Staff Report

To: Salt Lake City Historic Landmark Commission
From: Aaron Barlow, Principal Planner, 801-535-6182
Date: January 6, 2021
Re: PLNHLC2021-00924

Minor Alteration

PROPERTY ADDRESS: 224 West Ardmore Place
PARCEL ID: 08-36-255-035-0000
MASTER PLAN: Capitol Hill
ZONING DISTRICT: SR-1A Special Development Pattern Residential District
HISTORIC DISTRICT: Capitol Hill
COUNCIL DISTRICT: District 3, Chris Wharton

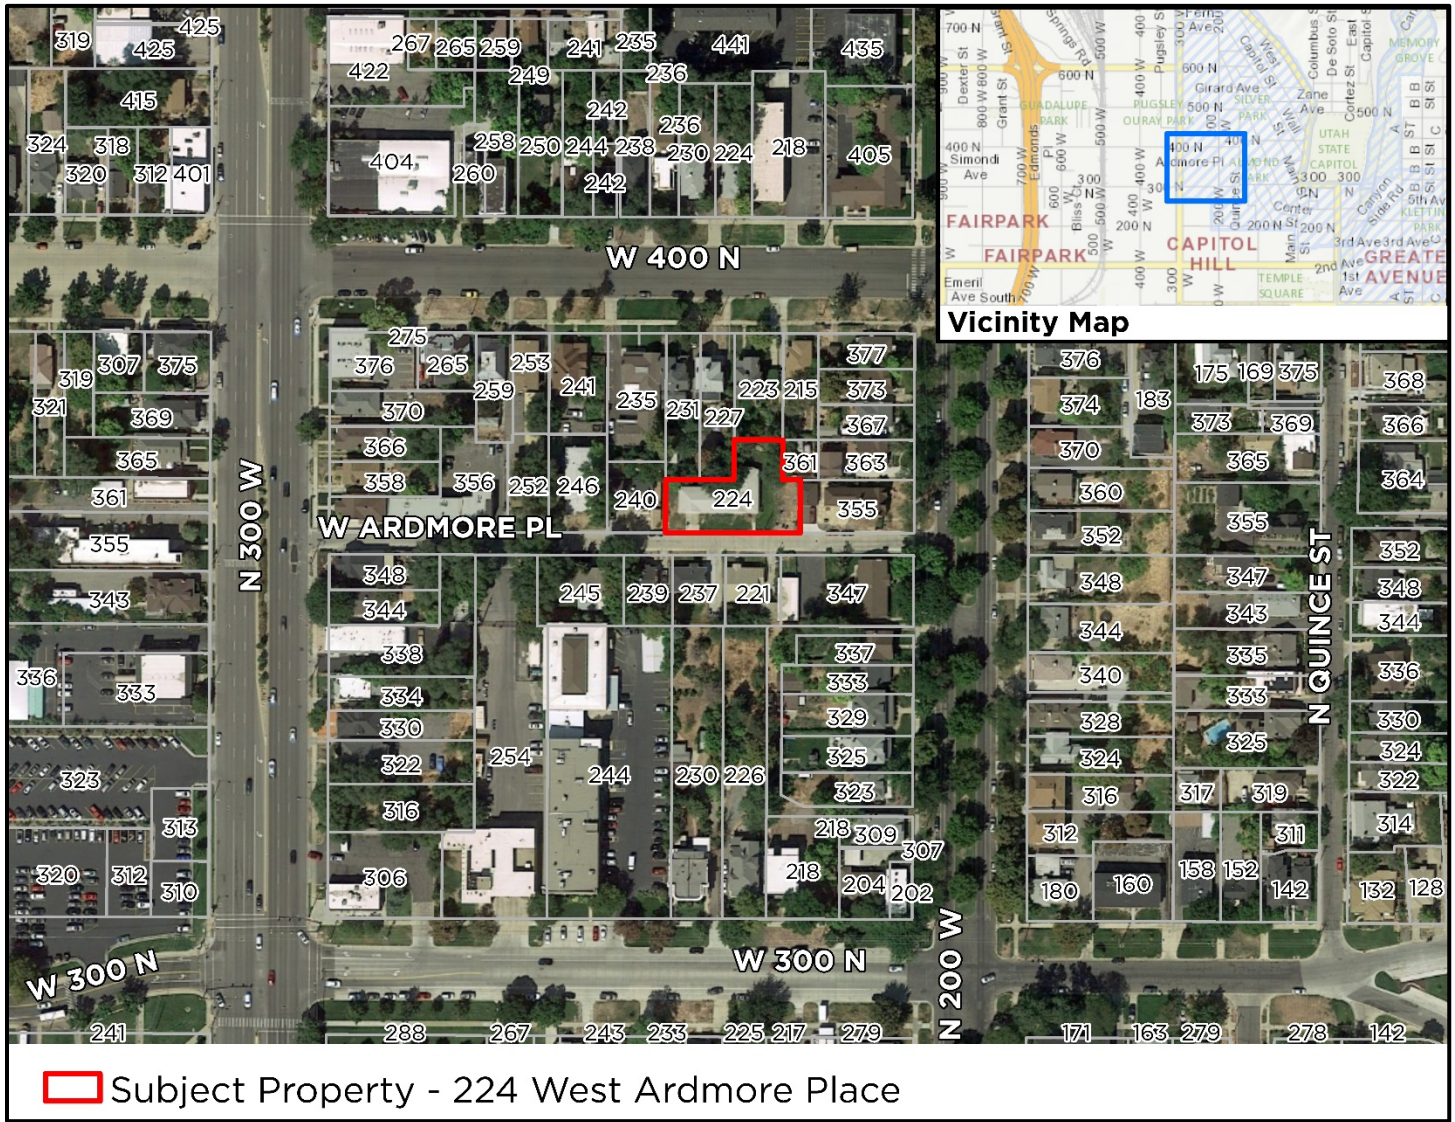
1. The proposed fiberglass windows do not meet the standards for a certificate of appropriateness because they are a different color, have a wider trim, and include a muntin grid not present on the original windows. The change in window character would negatively impact the historic character of the property and the district.
2. There is insufficient evidence to dispute the subject property's eligible contributing status in the Capitol Hill Local Historic District.

If the proposed replacement windows were similar in color, dimensions, and details to the originals, then staff would be more likely to recommend approval to the commission, even if the existing windows were in relatively good condition. However, the proposed windows are different enough from the original to impact the character of the subject property and the district.

If denied, the applicant would either need to repair the existing windows on the primary façade or replace them with new windows with identical dimensions and a similar appearance.
